**HI-STORM 100MB LAR 9378-1**  
**Responses to Requests for Additional Information**  
**Enclosure 2 to Holtec Letter 5026009**

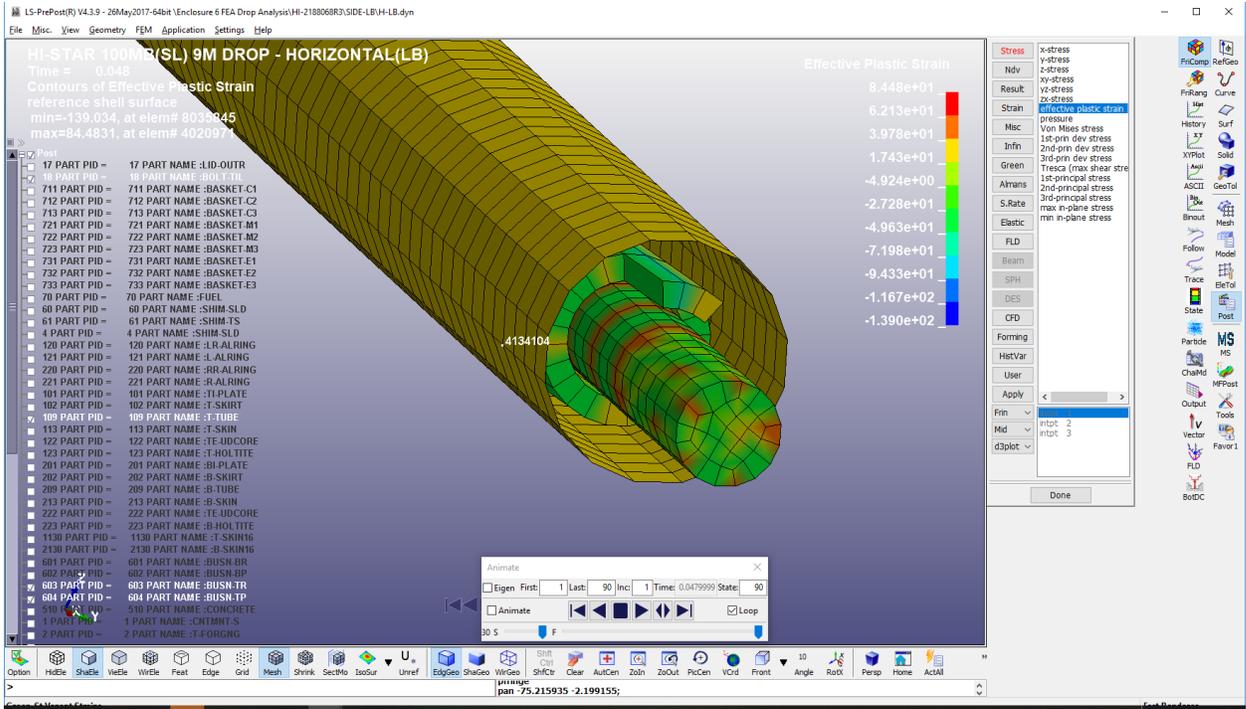
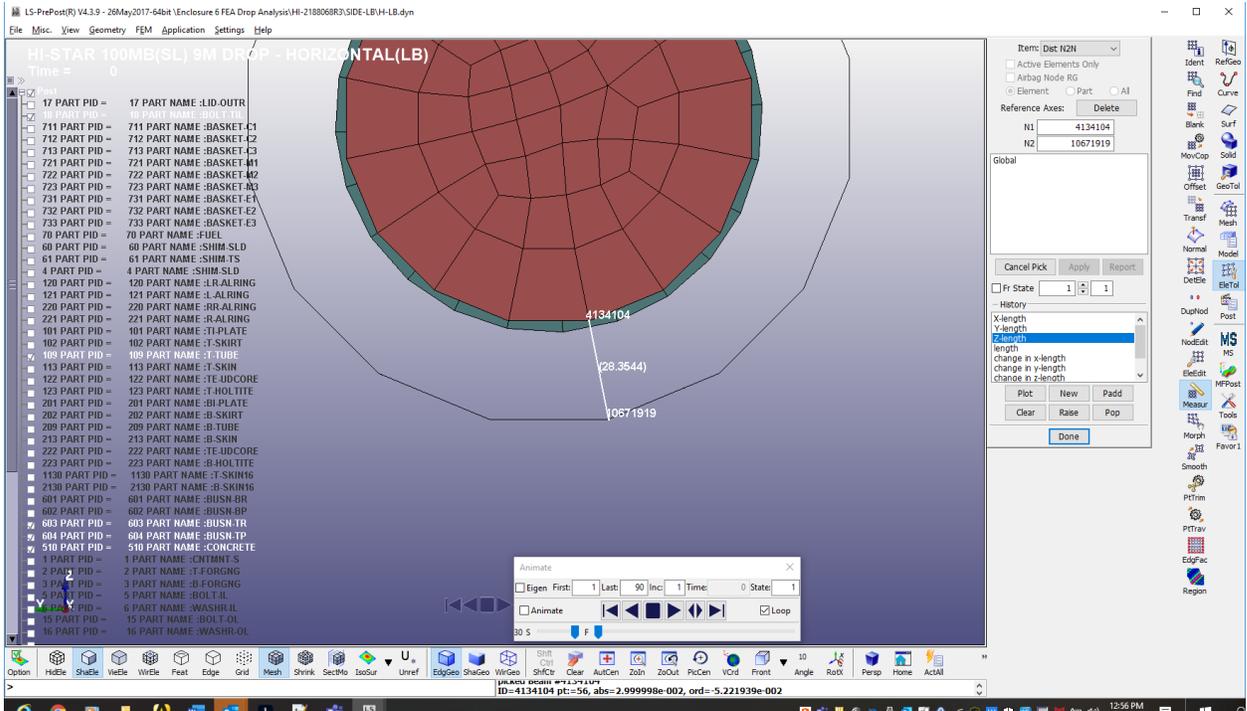
2-1 Clarify the behavior, dimensions, and material properties of the Fastener Strain Limiters (FSLs aka bushings) that are used to ensure that impact limiter bolts adequately retain the impact limiters post drop test scenarios. Justify how the access tubes that house those FSLs are NITS and why they do not need dimensions and material properties.

Describe the structural integrity of the impact limiter bolts with appropriately dimensioned access tubes and bushings (FSLs) with a more realistic failure model used for the bushings. Place access tube (BOM 9) dimensions along with bushing dimensions on the licensing drawings, mark them as ITS, and describe the material of the access tubes.

Additionally, the bushings also appear to fail in a combination of compression and bearing according to simulation, and not just tension. The calculations/LS-DYNA drop simulations assume that when the bushings reach a very small amount of inelastic strain (0.001) during the simulation, the bushing material that has yielded will be removed from the simulation. This does not appear to be a conservative assumption since the material will most likely remain in the simulations and will continue to impart shear/tension and bearing forces on to the impact limiter bolts when in contact with the access tube past this very small inelastic strain. In effect, by removing bushing material prematurely, the load path is also removed prematurely. The force in the impact limiter bolt, access tube, and bushing is not insignificant despite the applicant's non-conservative assumption, as inelastic strain plots indicate (9m side drop shown below):

In addition, the access tube shown above (yellow tube) (i) has no dimensions defined in the drawing (assumed to be 1/8" thick in LS-DYNA), (ii) is generically assigned stainless steel material properties, and (iii) comes into contact with the bushing/impact limiter bolts contained within the access tube. To demonstrate this, the gap between the tube and bushing is tracked during the 9m side drop (see graph below). The graph suggests that additional shear and bearing forces are being transferred into the impact limiter bolt.

The Fastener Strain Limiter (FSL) is designed to limit the tensile load experienced by the impact limiter attachment bolt as the impact limiter tries to detach from the cask during a drop accident. [

To address the concern that the larger diameter lower bushing, following the failure of its internal lip, may slide towards the attachment bolt head and get trapped by the deformed access tube resulting in a greater interaction than that between the upper bushing and the access tube, the ODs of the two FSL cylinders in LS-DYNA model are increased to 2.75" (i.e., the OD of the actual lower bushing) to maximize the interaction between the access tube and the FSL in a sensitivity analysis for the side drop event. This conservatively augmented tube-to-FSL interaction occurs over the entire FSL length at every attachment bolt location, regardless of the actual condition of the FSL lower bushing. Comparing with the original side drop analysis, this sensitivity run results in failure of one FSL installed on the bottom impact limiter, and the net effect is best measured by comparing the peak decelerations of the cask baseplate of the two simulations presented in Figures 2-1.A and 2-1.B. It is shown that the maximized tube-to-FSL interaction only slightly increases the peak deceleration at the cask baseplate by 3.9% (i.e., from 76.31 g's to 79.29 g's). Therefore, the undersized FSL lower bushing OD used in the LS-DYNA drop analysis has minimal impact to the analysis results. The sensitivity run described above is documented in revised Holtec report HI-2188068, Appendix G.

Finally, the primary function of the impact limiter access tubes is to ease the impact limiter installation. The access tube itself does not play any safety role as a collapsed access tube will not result in any radiological consequences. Moreover, access tubes absorb a negligible amount of energy during impact as compared to the substantial volume of aluminum crush material. Regardless, the access tubes have been redesignated as ITS-C components on licensing drawing No. 11758 to assure that their material strength properties conform with the analysis.

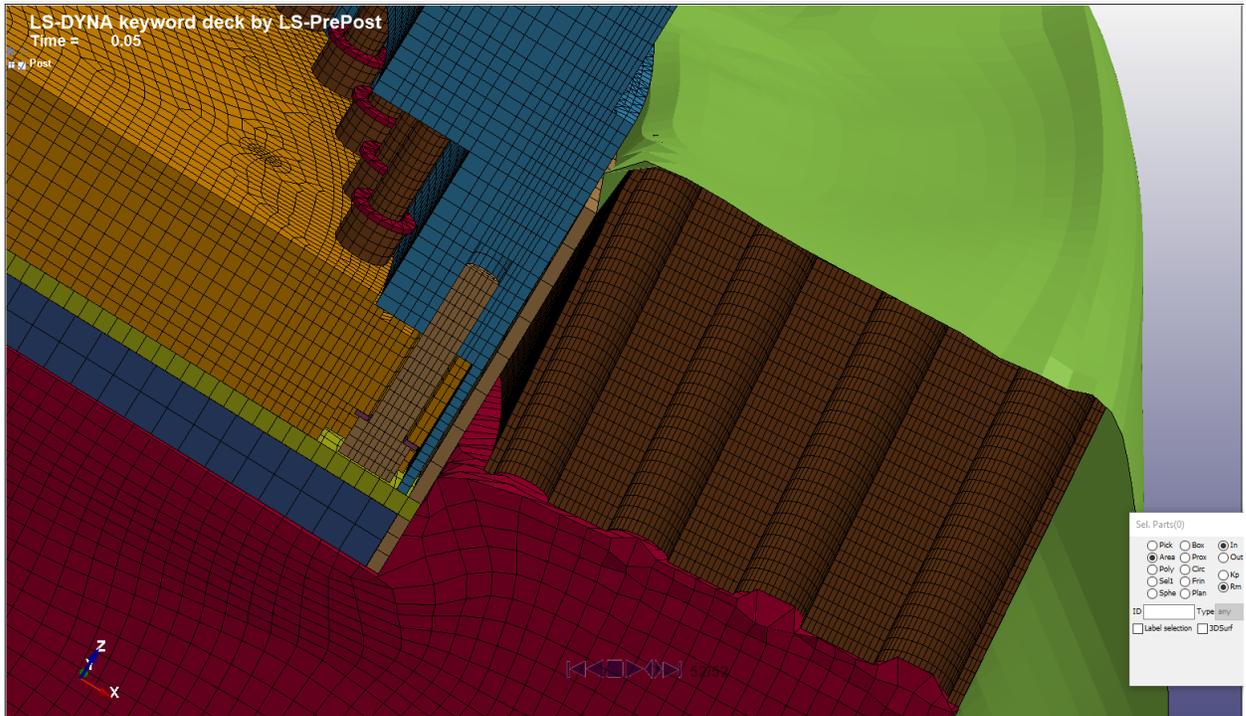
The applicant's response to the first round of RAIs (ADAMS No. ML20258A052) included revised simulations such as the 9m end drop simulation, which incorporated changes to the impact limiter. This simulation should result in symmetric output for quantities such as deformation and stress due to the symmetric of the model and loading. The results are not symmetric as can be seen below (several parts have been removed for clarity):

In addition, boundary conditions appear to be assigned incorrectly, as lead shielding appears to be “ghosting” past other parts, especially in the plane of symmetry of the half model, leading to a lead slump of approximately 6.5 inches and opening a “seam” between the lead and the gamma shield rib that is 2.5”wide, (0.75” originally) and approximately 24” long (several parts have been removed for clarity). Staff notes also that the lead slump is not symmetric away from the plane of symmetry either.

The issue of lead penetration through the symmetric plane of the half model found in the vertical drop simulation is the result of a missing contact definition between the lead and the cask ribs on the symmetric plane of the HI-STAR 100MB package half model. The penetration problem did not occur in other drop orientations. The predicted package deformation obtained from the revised model and shown in Figure 2-3.A below demonstrates that the lead penetration problem has been corrected. The unsymmetric impact limiter deformation noticed in the previous vertical drop simulation is an unintended consequence of a modeling simplification that is employed for the side and oblique drop simulations. For those drop orientations, the perforated aluminum ring is modeled as a deformable body with element erosion enabled only over its lower half (nearest to the target surface), while the upper half is modeled as rigid. This modeling approach is used to increase the run time efficiency of the LS-DYNA solution for the lateral drops, with minimal effect on the results, since the permanent deformation/damage to the perforated aluminum is localized near the point of impact. The same half rigid, half deformable model of the perforated aluminum ring was mistakenly carried into the vertical drop simulation, which caused the unsymmetric impact limiter behavior. The revised LS-DYNA model fixes the error by treating the entire ring as a rigid body for a conservative analysis of the vertical drop accident since the impact energy is essentially absorbed by the honeycomb crush material at the very end of the impact limiter. The symmetric impact limiter deformation obtained from the new vertical drop analysis is also demonstrated in Figure 2-3.A.

The maximum lead slump obtained from the newly obtained vertical drop analysis is less than 4.2 inches as shown in Figure 2-3.B. The predicted lead slump is bounded by the value considered in the shielding analysis. The acceleration and stress results obtained from the revised model are slightly different than before and are documented in the revised drop analysis report HI-2188068 Rev. 4 and in Chapter 2 of the updated HI-STAR 100MB SAR.

Region of eroded elements in the perforated ring region at the end of the 9m drop simulation:

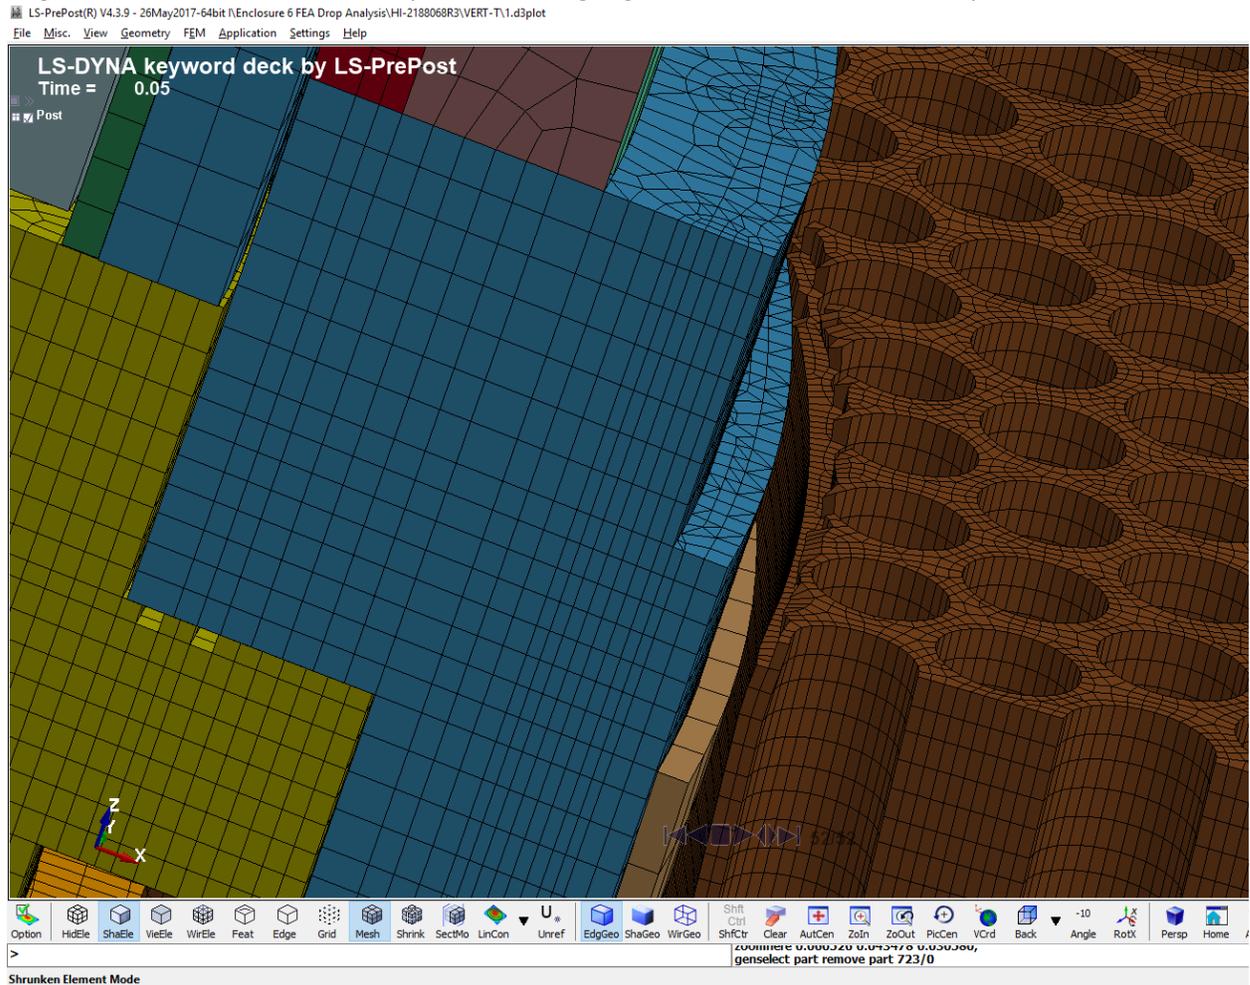
In addition, material erosion in LS-DYNA should apply to parts other than the perforated ring. Specifically, the impact limiter skin which is made of unknown 10/16 gauge material (details are not provided on the licensing drawings), does not appear to ever fail (tearing, puncture, etc) when in contact with the sharp corners of the solid aluminum perforated ring. Instead, the perforated ring erodes unrealistically when in contact with the skin at certain points in the simulation, particularly where the impact limiter skin wraps over the perforated ring, and never detaches from the skirt (Part 102 (T-Skirt) in LS-DYNA). Staff notes that the impact limiter skin to skirt connection is not provided on the licensing drawings while the impact limiter skin sustains stresses beyond 100,000 psi without tearing or “failing”:

The impact limiter enclosure skin is made of a very ductile type 304 stainless steel with a true failure stress greater than 100,000 psi, for material temperatures below roughly 800°F, as demonstrated in the following true-stress-true-strain curve (see Figure 2-3.C) taken from the book *Atlas of Stress-Strain Curves* (Second Edition, ASM International). Consistent with Holtec licensing drawing No. 11758, the impact limiter stainless steel enclosure skin is 16 GA thick at the end surface of the package and 11 GA thick at other locations. The revised licensing drawing will be updated to include the material information for the

impact limiter enclosure skin and show how the skin and the access tubes are connected. Code requirements (fabrication and examination) for the weld connections and for all NITS and ITS components will also be identified in the revised licensing drawings. To address the concern that the impact limiter enclosure skin may fail due to an unfavorable stress state, an LS-DYNA sensitivity run is performed for the governing oblique drop scenario documented in Appendix G of HI-2188068 Rev. 4. In addition to the lower bound service temperature (-40F) considered for the enclosure skin material property, the LS-DYNA sensitivity run accounts for triaxiality effects on the failure strain of the enclosure skin material (SA-240 304). The triaxiality effect is incorporated per the general statement in ASME BPVC.III.A, Appendix EE. Namely, the strain at failure in a general case is equal to the uniaxial tension failure strain divided by the triaxiality factor, where the triaxiality factor is the larger of calculated value and unity (1.0). The sensitivity run yields similar enclosure skin plastic deformation as shown in Figures 2-3.D and 2-3.E. Both the original LS-DYNA simulation and the sensitivity run indicate that the impact limiter enclosure skin only experiences local plastic deformation without gross failure. Therefore, the concern of increased package vulnerability to the HAC fire accident due to enclosure skin gross failure is not credible. Holtec's 9-m drop tests performed in 1990s for HI-STAR 100 package also arrived at the same conclusion for the same stainless steel impact limiter enclosure skin. In addition, a published ASME paper [2-3.1] reports a similar test result for a dropped canister, which experiences a plastic strain of 107% without initiating any cracks per the post-impact non-destructive examination. The deformed shaped of the dropped canister is shown in Figure 2-3.F. The sensitivity run described above is also documented in the revised drop analysis report HI-2188068 Rev. 4.
